## **TSB 97-16-7**

-----  
This TSB article is being republished in its entirety to update case and gasket part numbers.

**ISSUE:**

A new transmission case and main control have been released for service on 1992-95 AODE/4R70W transmissions.

Figure 1 - Article 97-16-7

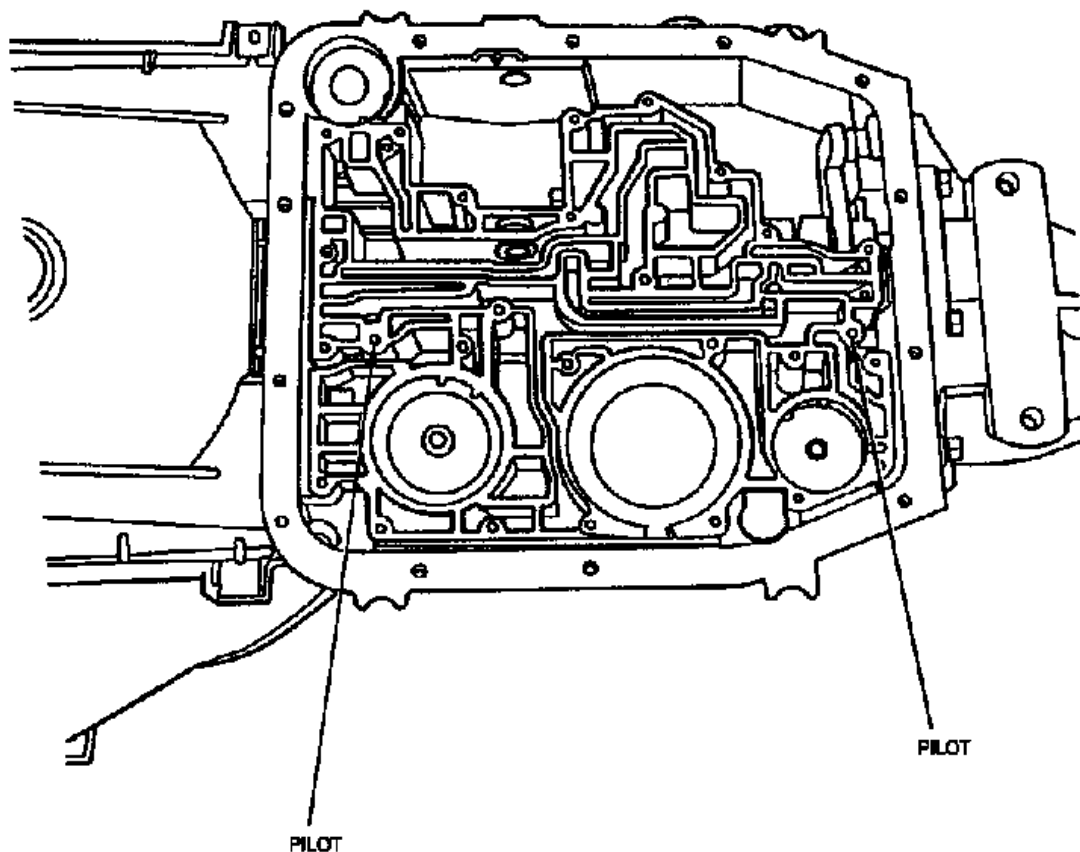
The new transmission case pilot holes (used to align the main control) have been reduced to accommodate the smaller pilot bolts used in the new service main control.

When servicing a 1992-95 transmission case with a new 1997 case (see Case Application Chart) and reusing the original main control, the pilot bolts must be replaced with Bolts (N808962-S) and Gasket (F7AZ-7C155-AA).

The large tipped pilot bolts should be used to assemble the main control since it aligns the separating plate and valve body gasket. After the main control is assembled, remove and replace the pilot bolts with the new bolts. The reinforcing plate and separating plate bolts will keep the components in alignment. Refer to Figure 1.

WHEN REPLACING A 1992-95 MAIN CONTROL WITH THIS ASSEMBLY, YOU MUST INSTALL TWO (2) SLEEVES (F6AZ-7K720-A) IN THE MAIN CONTROL PILOT HOLES. TORQUE ALL BOLTS 9-11 N·m (80-100 LB-IN) AS OUTLINED IN THE APPROPRIATE SERVICE MANUAL.
